Re: 2400 E Atlantic Ave Pompano Beach, FL

Florida Power and Light Response Letter

PZ25-12000001

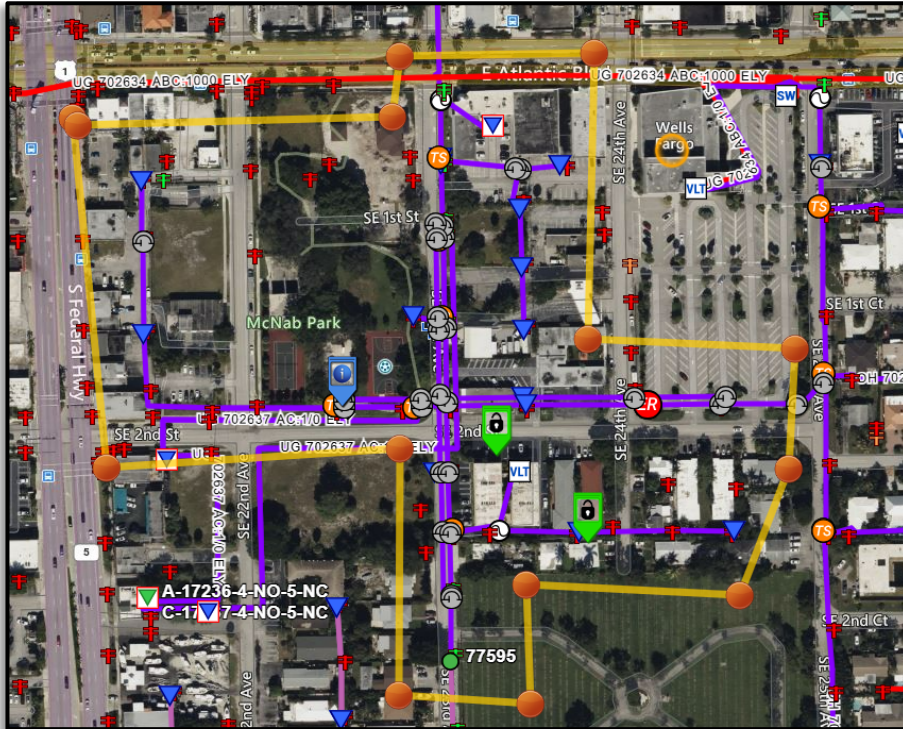
Regarding the south side of the property:

Additionally, while the 1000 foot or 2 block requirement is what we are required to offer for consideration, I would like to point out that the existing facilities on the south of the property heading east along SE 2nd St would likely see a net negative impact on the strength of the grid if converted in the event it is limited to this constraint. I highly doubt that our area management team would approve us from an engineering side to perform the conversion unless it encompasses everything on our feeder 702637 that is south of E Atlantic Blvd between S Federal Hwy and SE 25th Ave as this area is fairly congested with a lot of Automatic Lateral Switches [ALS]. To be clear, ALS are a technology that further works to isolate a fault on our lines by first trying to troubleshoot the fault before opening the fuse. An underground equivalent is currently in the testing phase with our product engineering department, but as it stands now, they are not available for implementation in the field. I cannot say with full confidence that, even with the area outlined in the attached image, the area planning team will be agreeable for this reason.
